Product Change Notification

PCN18-18-KSC2 Actuator

C&K

2. Overview

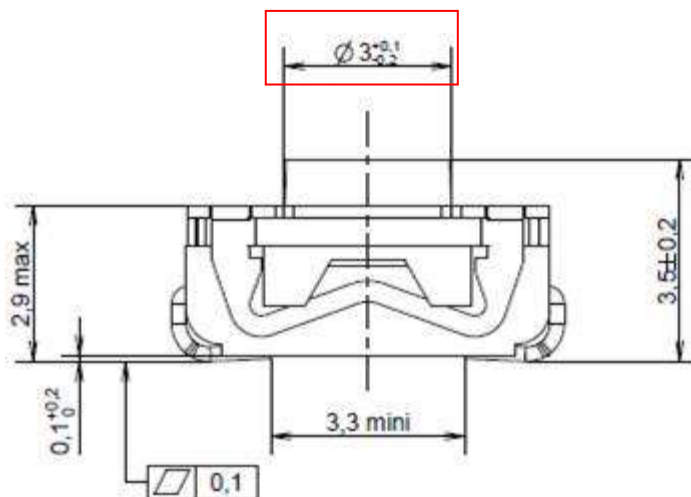
As part of this continuous improvement policy, we are presently correcting one dimension on our KSC2 drawings, on the actuator diameter

Before:

After:

There is no impact as we are correcting a drawing mistake. Product has always been at the dimension of 3.0 mm
